**TO:** Cassie Younger, Maverik, Inc.  
**FROM:** Stacey Nerger, Senior Planner  
**DATE:** September 28, 2022  
**SUBJECT:** SP21-133 Lincoln Professional Park Filing No. 1 Lot 1 Site Plan

# LINCOLN PROFESSIONAL PARK FILING NO. 1 LOT 1 MAVERIK INC. STORE SITE PLAN

HORIZONTAL CONTROL PLAN

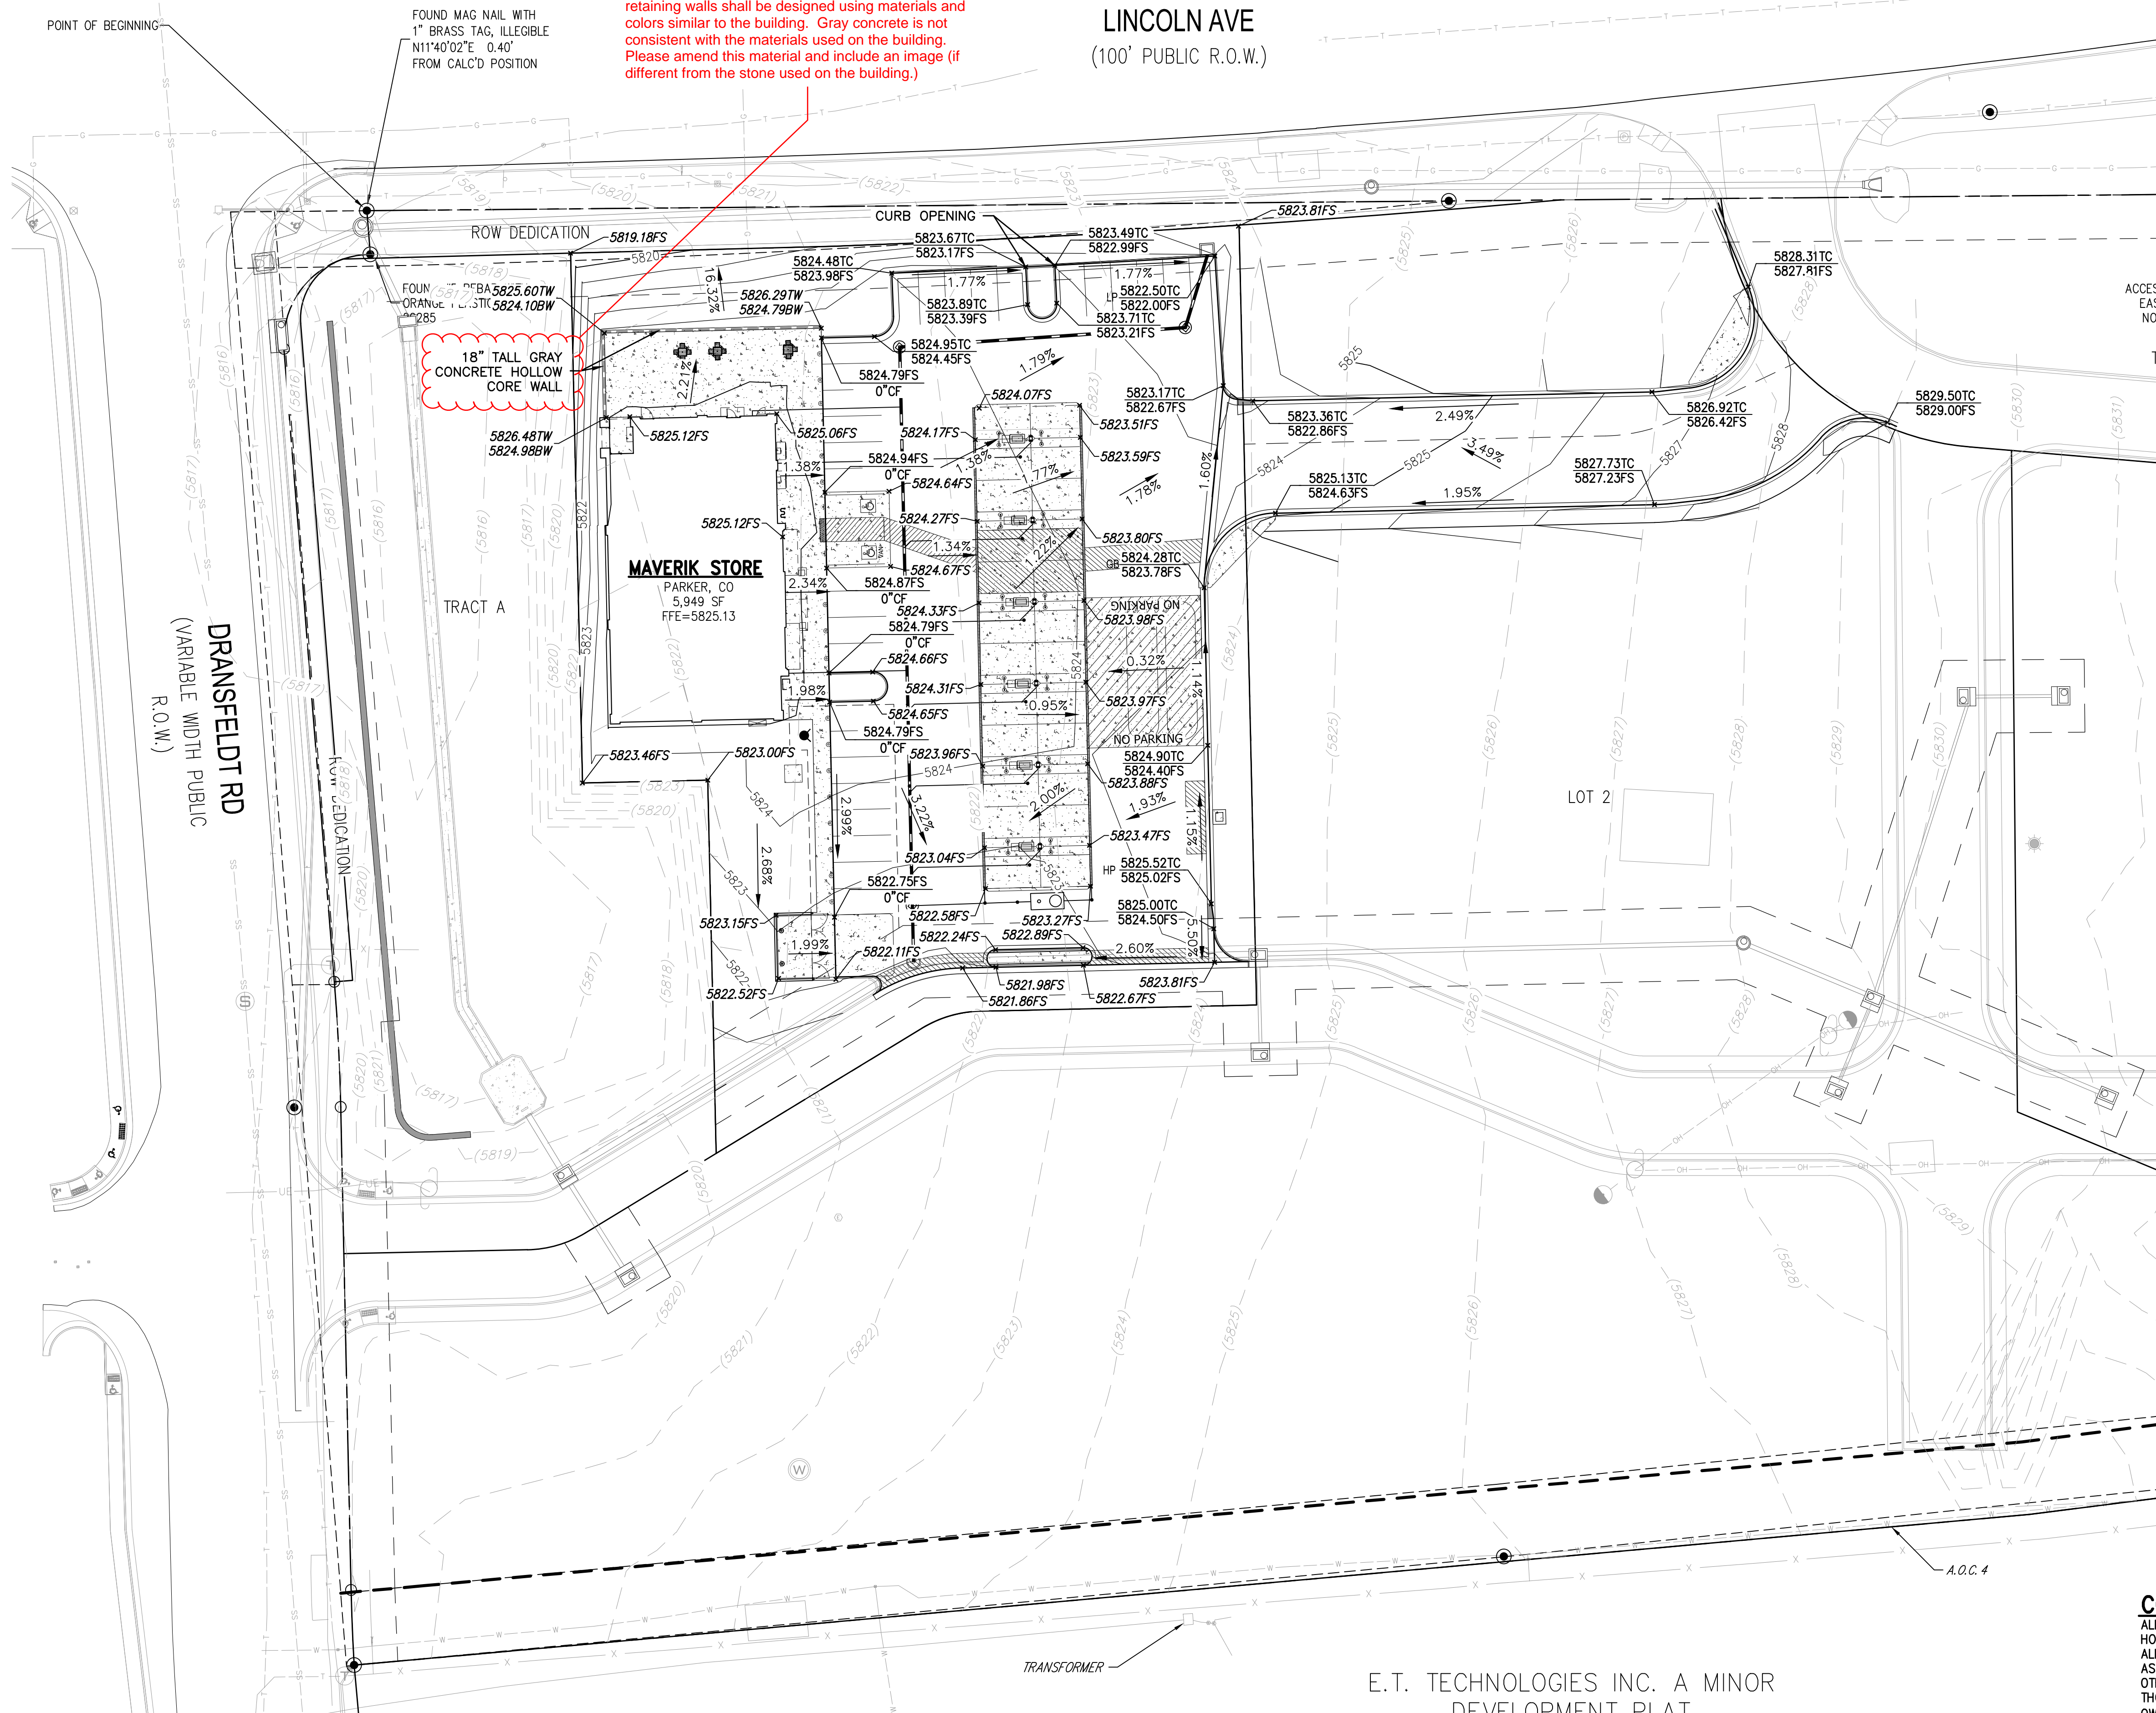
Staff understands that there is a slope to the sidewalk, but is there a way to create a pedestrian connection from the Lincoln Road sidewalk to access the building? Based on the Town of Parker Land Development Ordinance, pedestrian connections from the adjacent sidewalk to each commercial use is recommended.

Need a pedestrian connection into the site from the internal road. If walking in front of the trash enclosure is not preferred, a path can be added to west.

GRADING PLAN

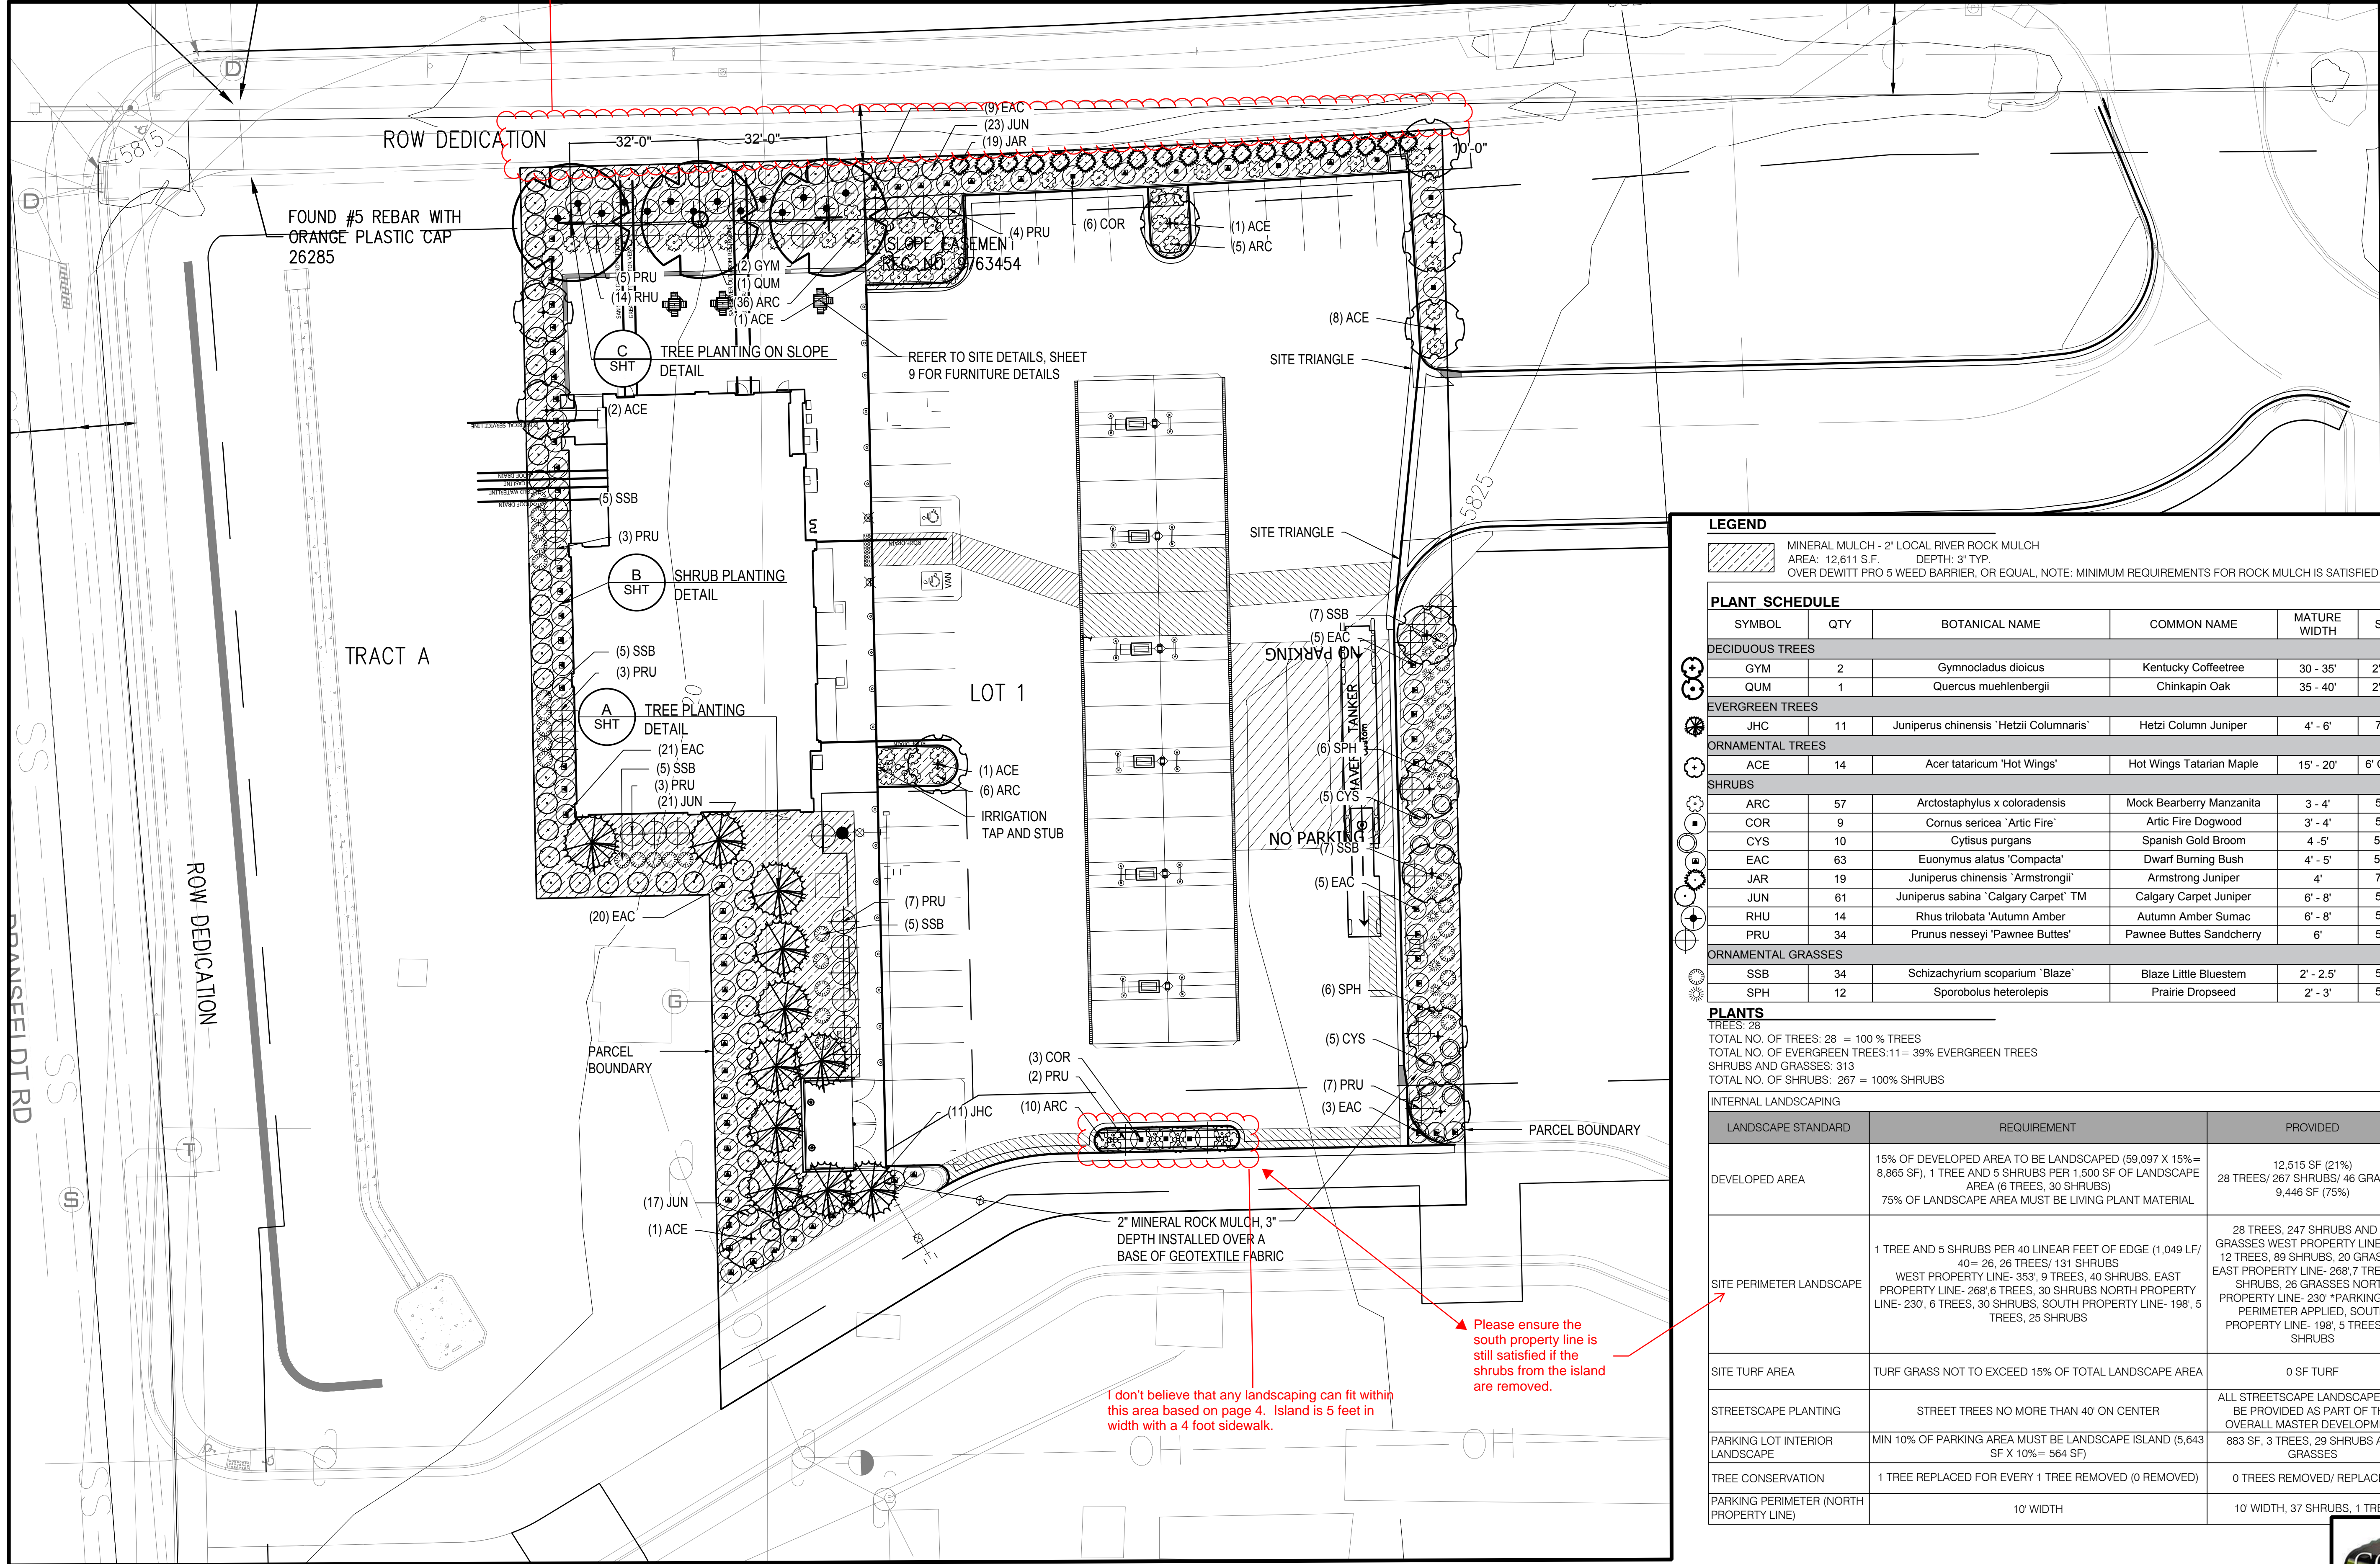
Thank you for including additional details, but please also include an image of the concrete on this page. All retaining walls shall be designed using materials and colors similar to the building. Gray concrete is not consistent with the materials used on the building. Please amend this material and include an image (if different from the stone used on the building.)
